Wollongong Local Planning Panel Assessment Report | 10 December 2020

WLPP No.	Item No. 4
DA No.	DA-2020/708
Proposal	Residential - alterations and additions to existing dual occupancy
Property	1/3 Hill Street, Bulli
Applicant	Illawarra Design Company
Responsible Team	Development Assessment and Certification - City Centre Team (HK)
Development cost	\$198,000
Lodgement date	18/07/2020
Prior WLPP meeting	NA

ASSESSMENT REPORT AND RECOMMENDATION

TITLE:	SITE PLAN
PROJECT:	ALTERATIONS + ADDITIONS TO DWELLING
ADDRESS:	1/3 HILL STREET, BULLI

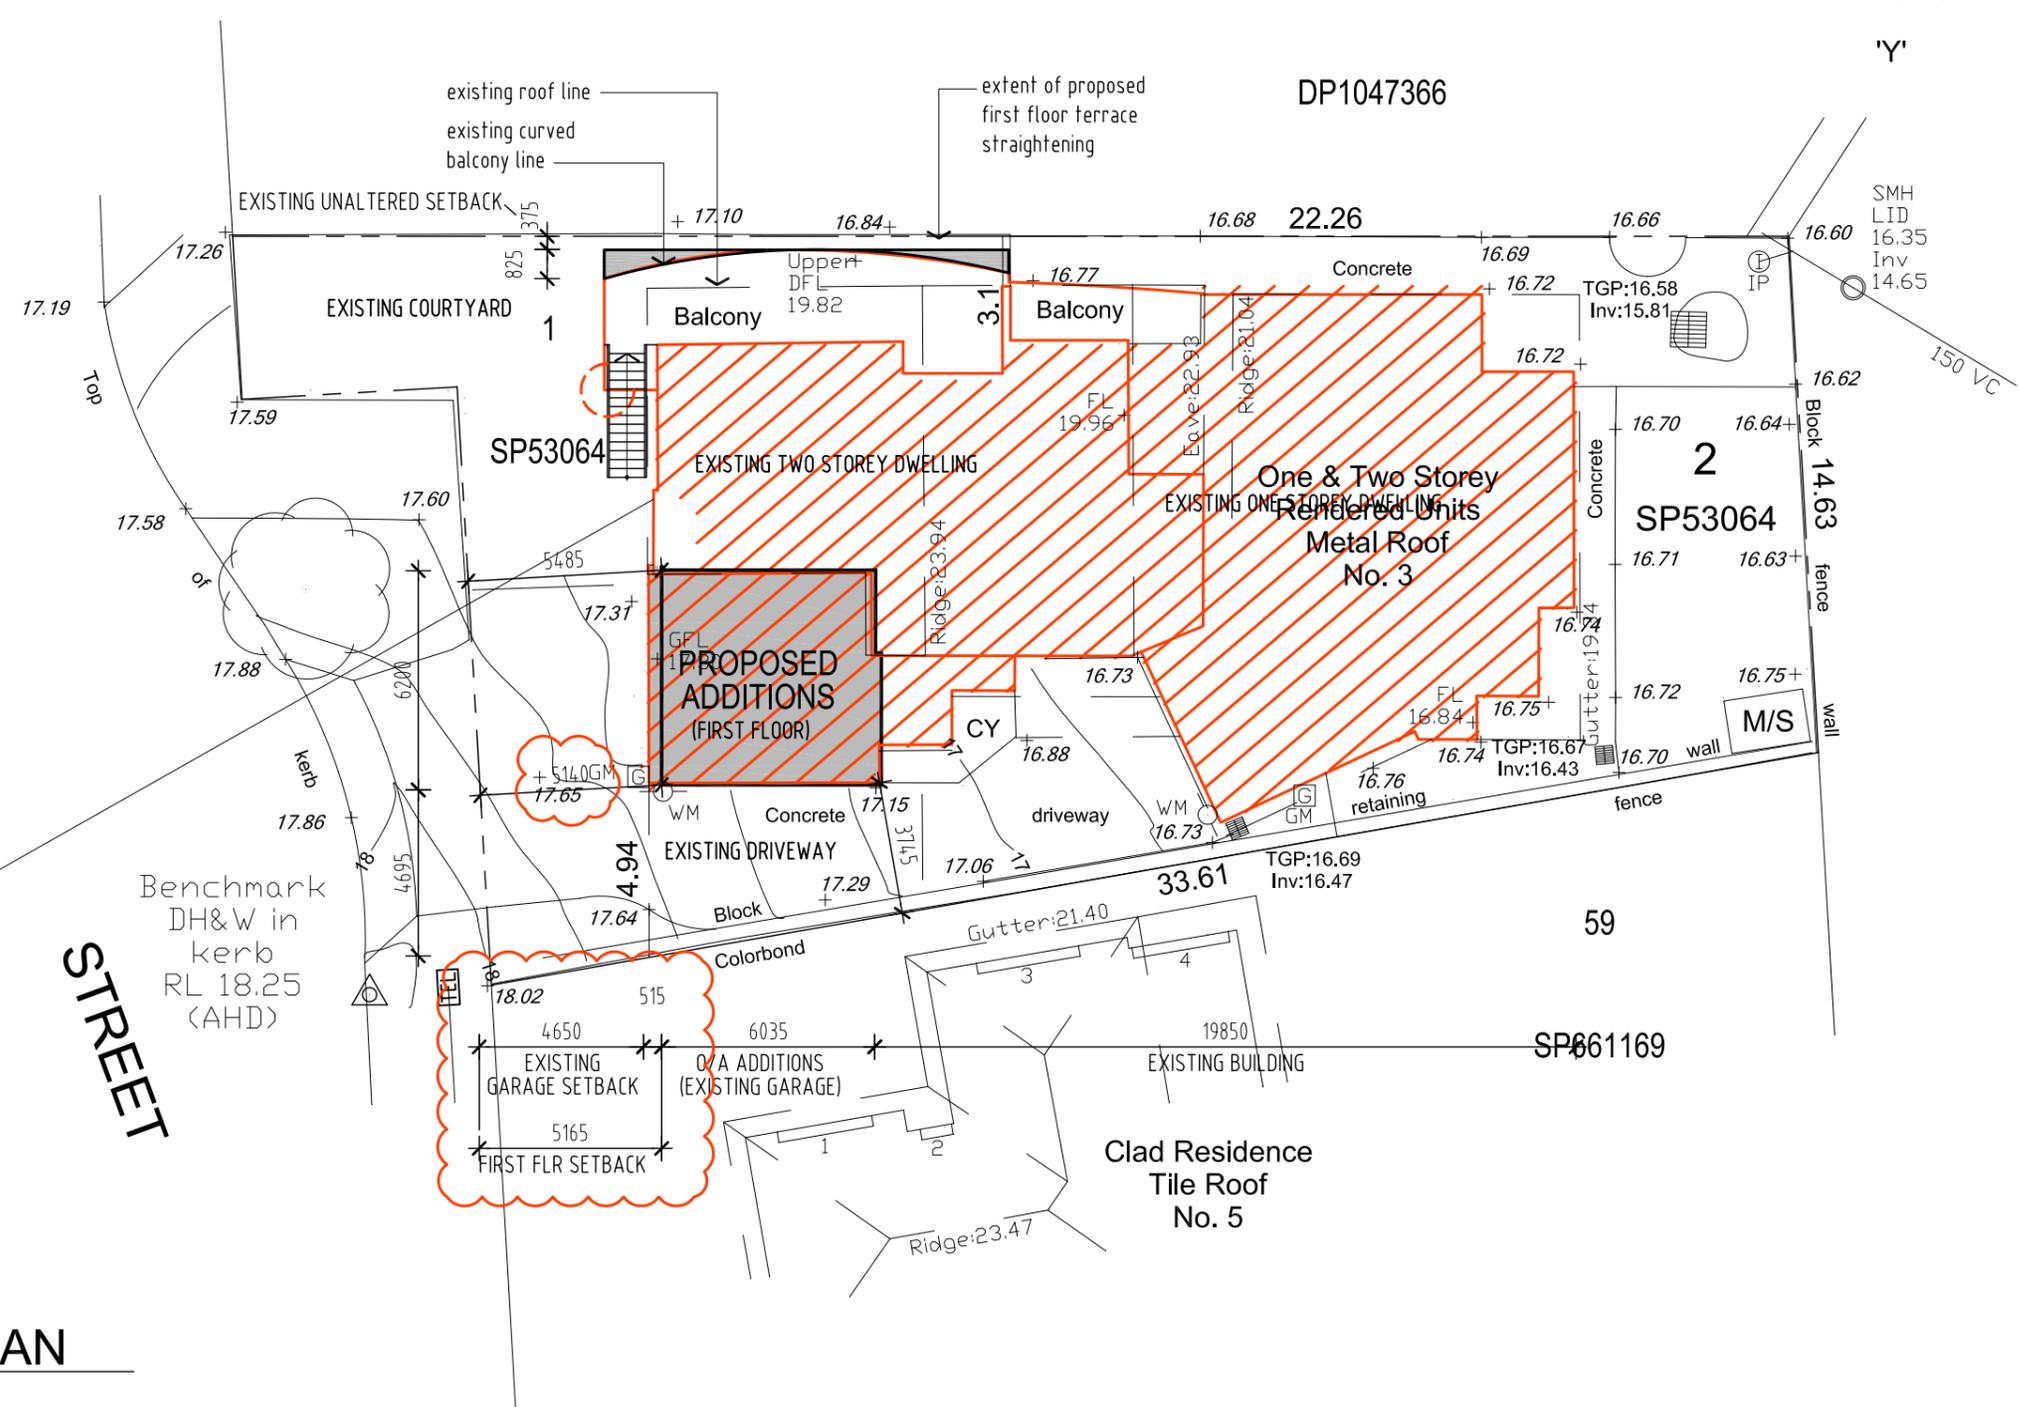
The original plans had a second storey window seat protruding out of the front façade and decreasing the front setback. This has been removed in a subsequent revision. The addition is now setback 5.1m which is in line with the existing dwelling.

TITLE :	PROPOSED FIRST FLOOR PLAN
PROJECT :	ALTERATIONS + ADDITIONS TO DWELLING
ADDRESS :	1/3 HILL STREET, BULLI

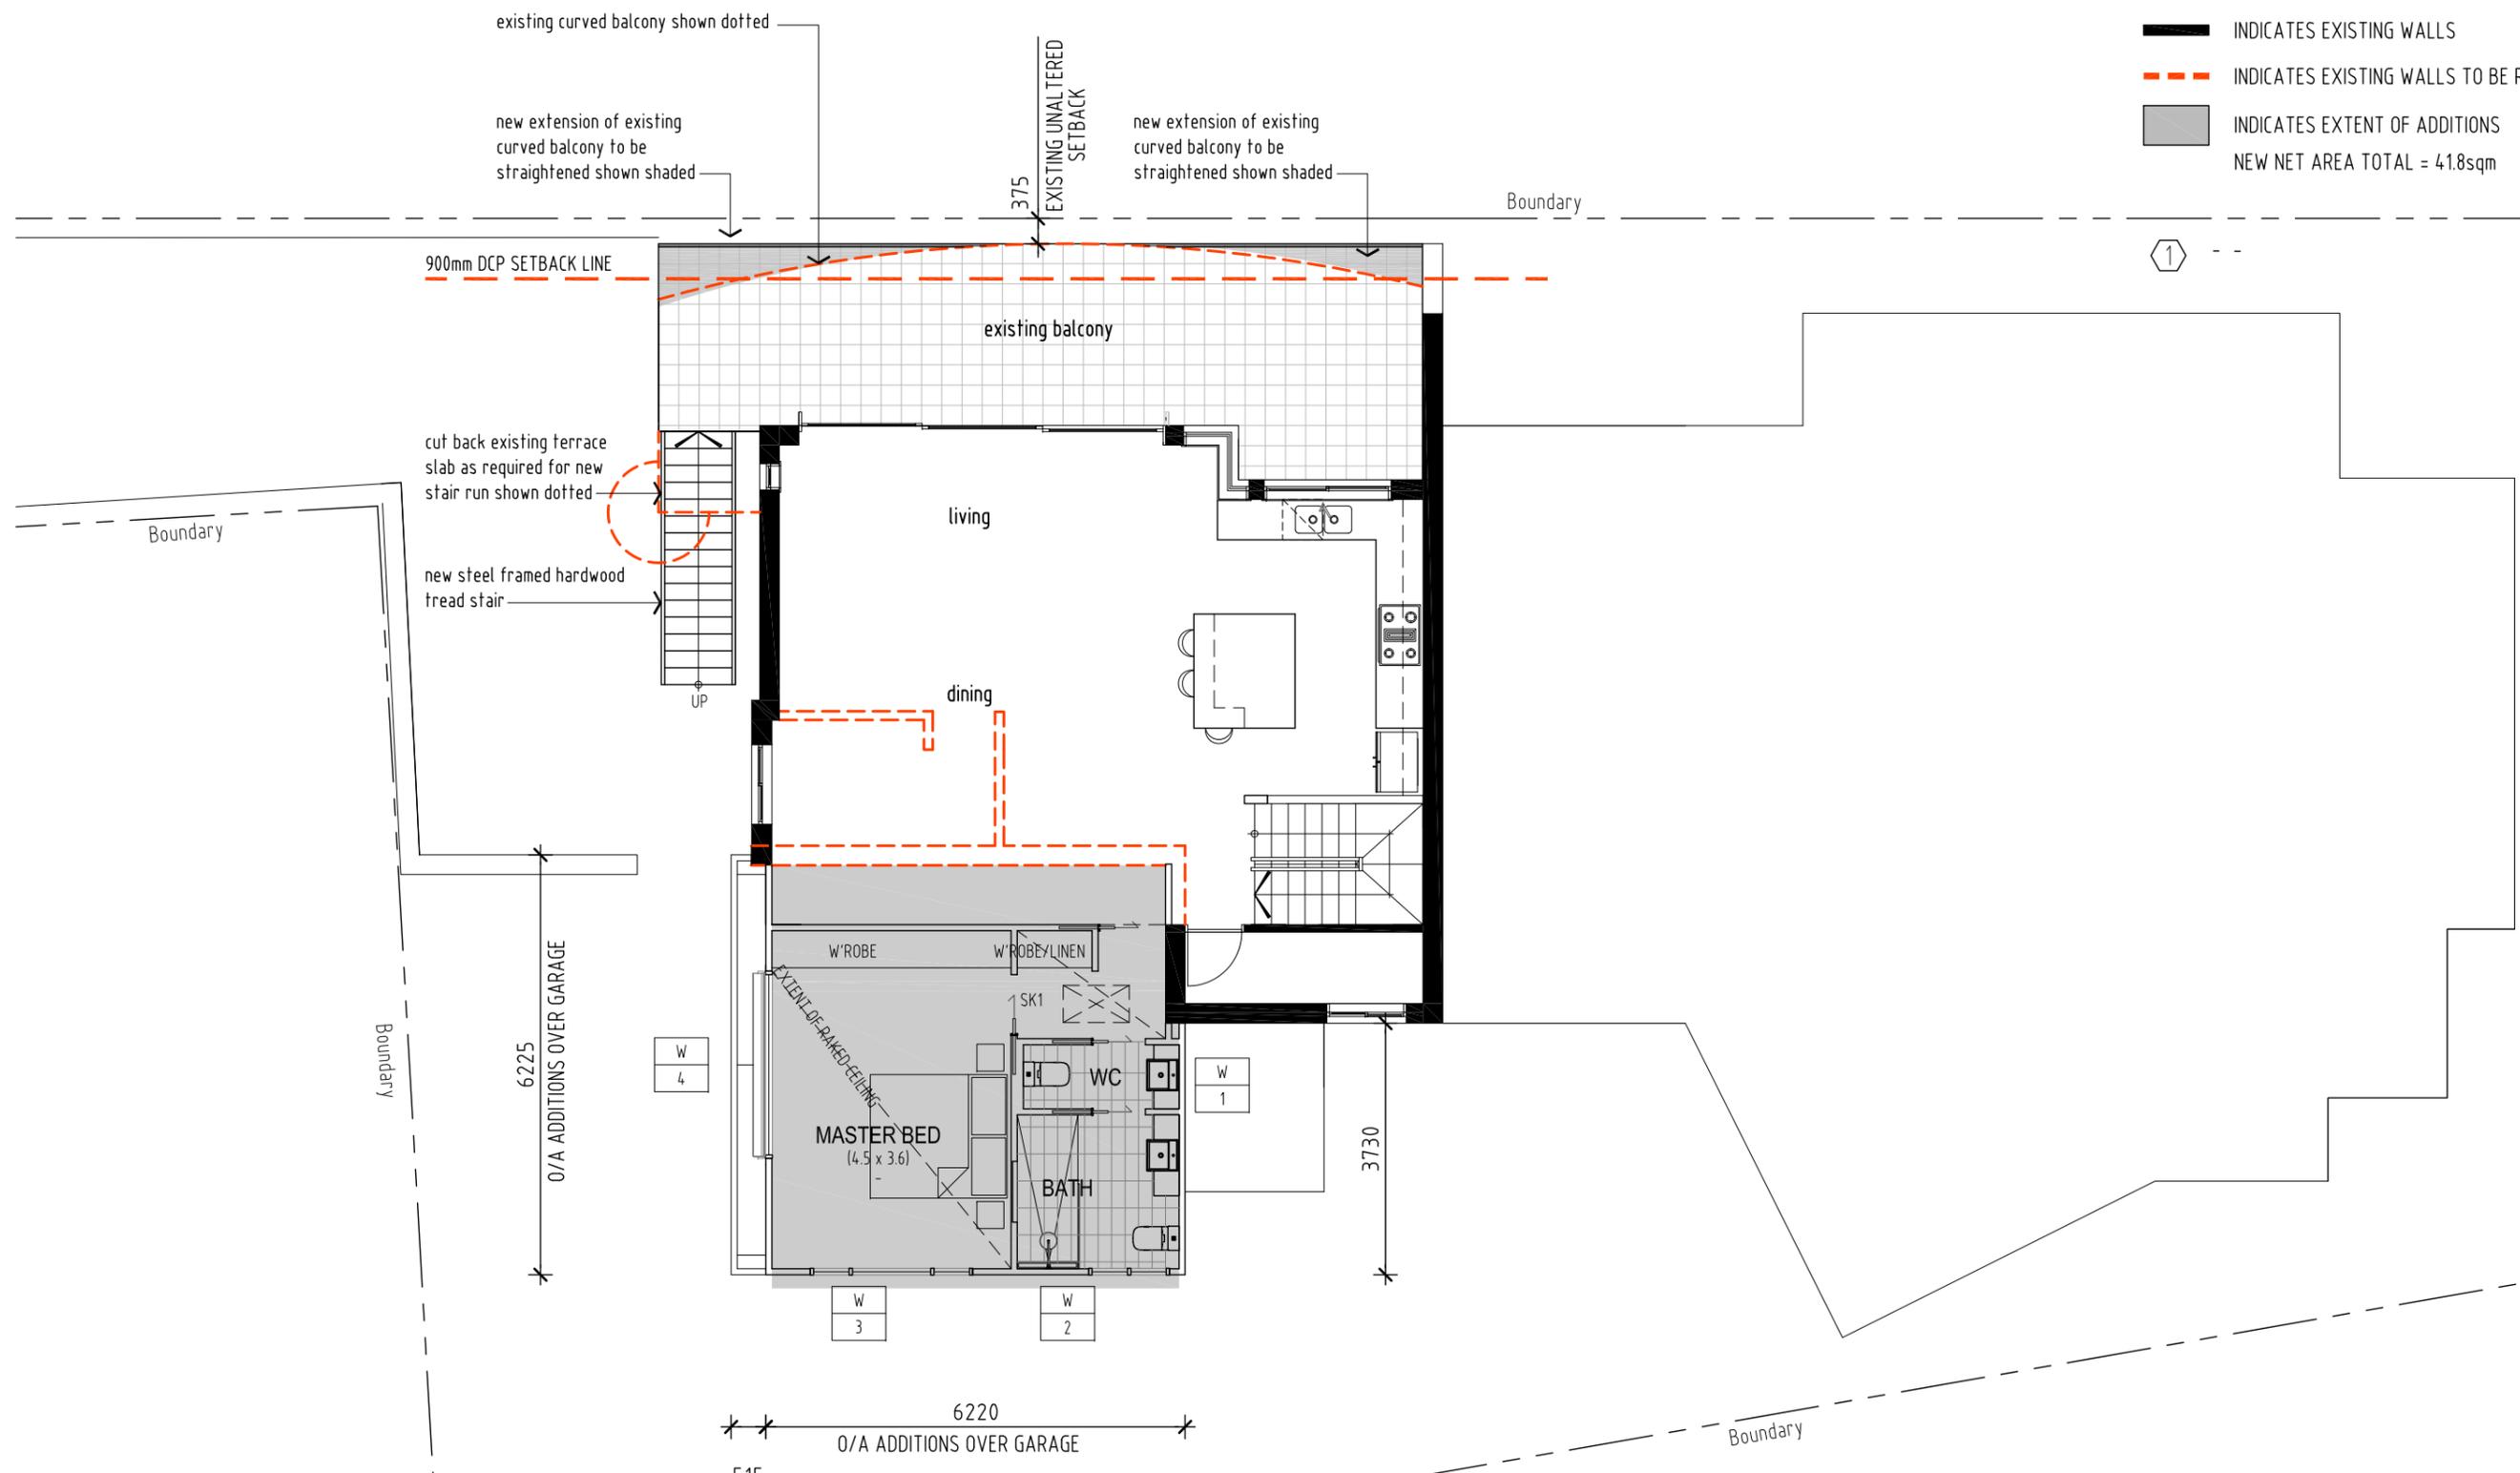
The balcony alterations are not supported and would require a variation to the side setback controls. While the side setback variation is historic, increasing the variation will have some visual impacts on the reserve, and could set an undesirable precedent. The additional encroachment into the 0.9 metre side setback provides little additional functionality or amenity to the occupants of the dwelling. In this context the design has not been suitably justified. With regard to (c) there will be a minor increase in bulk and scale when viewed from the surrounding public lands and coastal environment.

Prior to the issue of the construction certificate, the plans shall be amended to remove the proposed extension of the balcony beyond the 900mm DCP setback line. No new building element shall extend further than 900mm from the northern lot boundary.

A condition of consent is proposed that the alterations to the balcony be removed prior to the issue of the construction certificate.

SHADOW DIAGRAMS

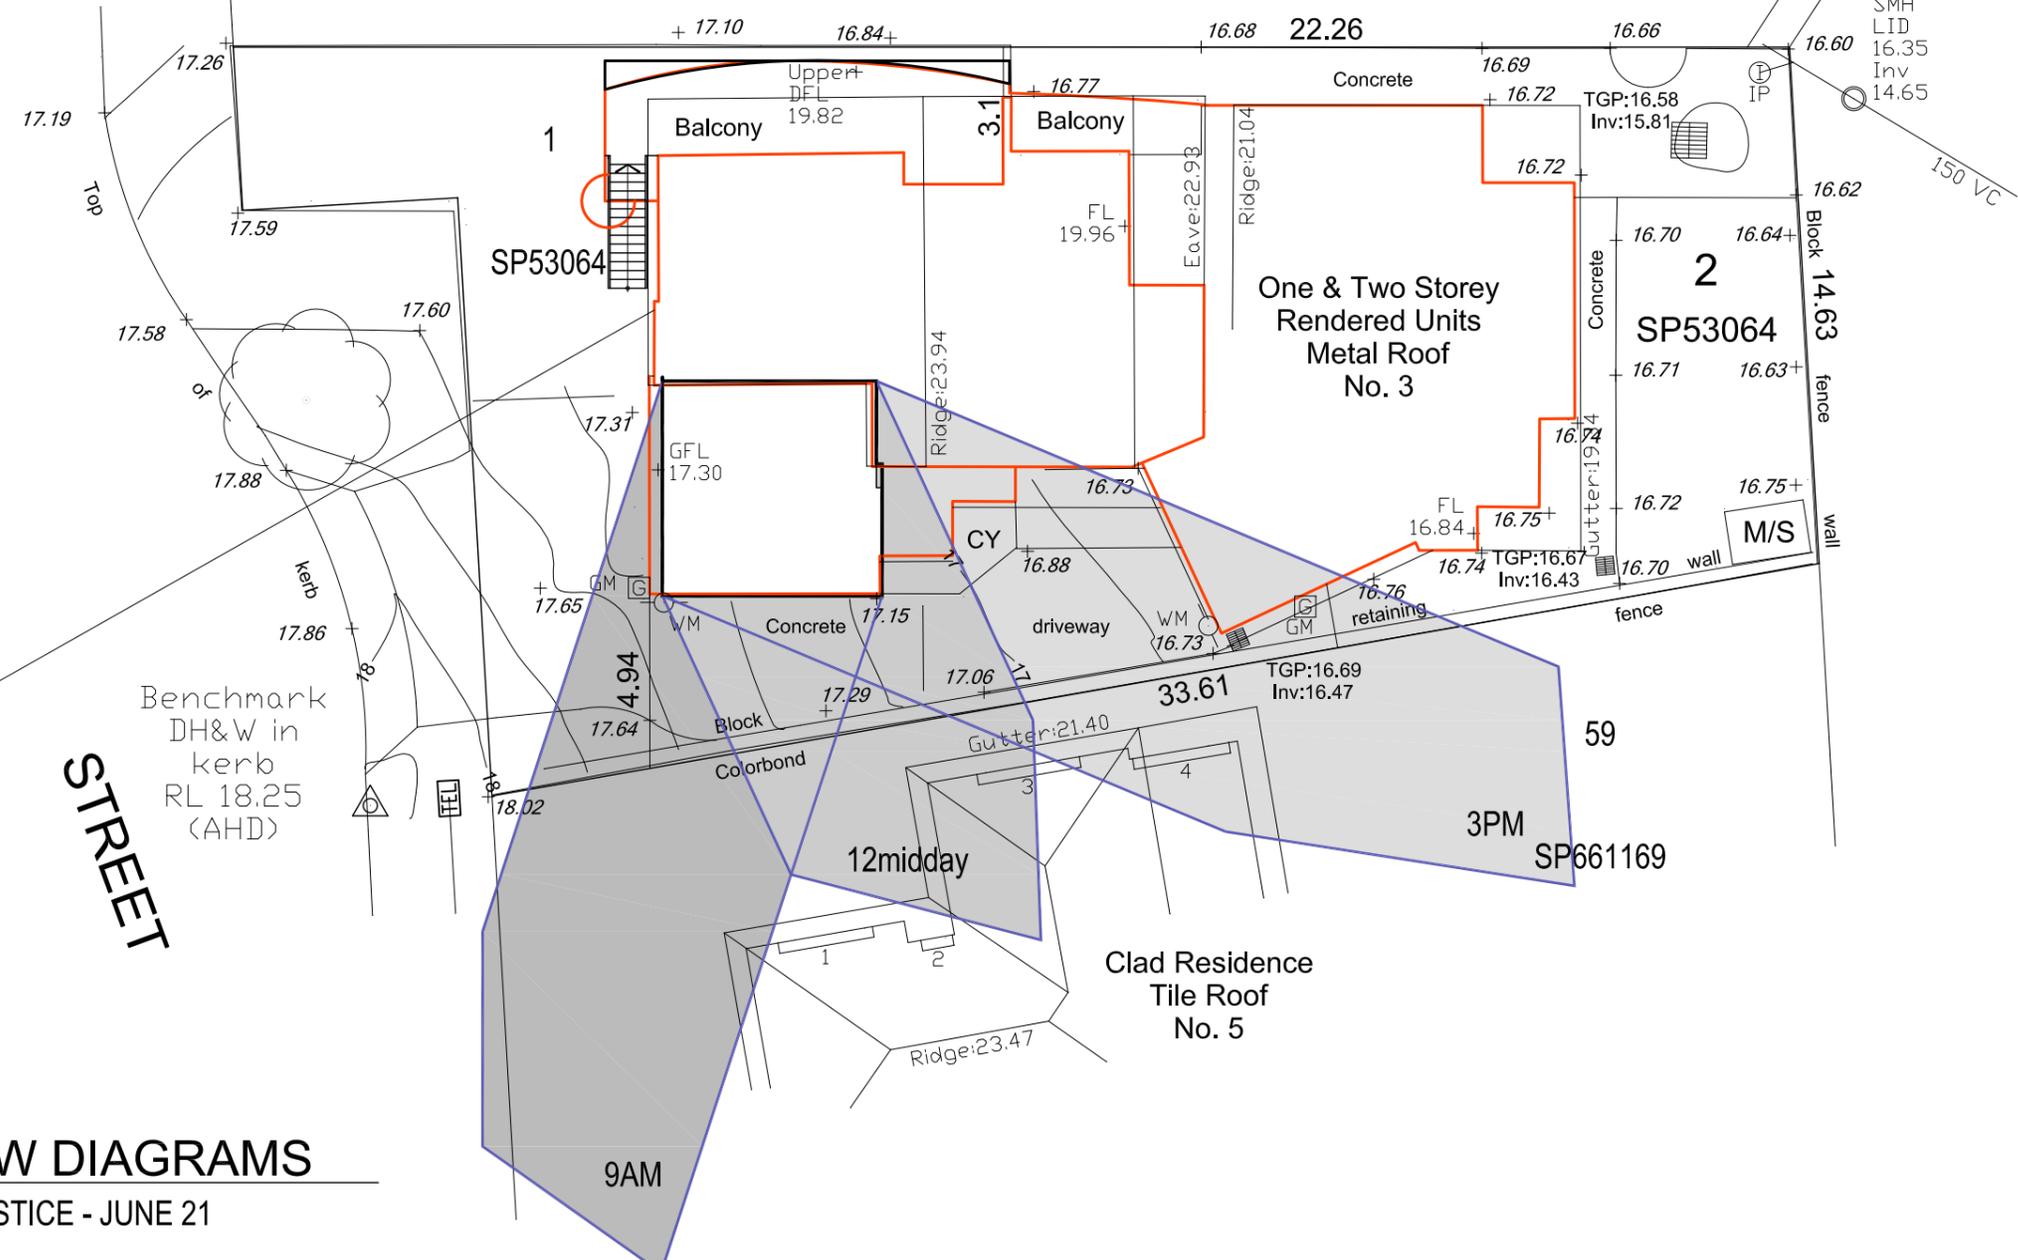
5. There will be overshadowing and loss of winter sunlight for the property to the south.	Solar access diagrams have been provided that only show the impacts of the proposed additions. The diagrams do not account for the overshadowing which exists from the existing building. The proposal will result in some overshadowing of the property to the south.
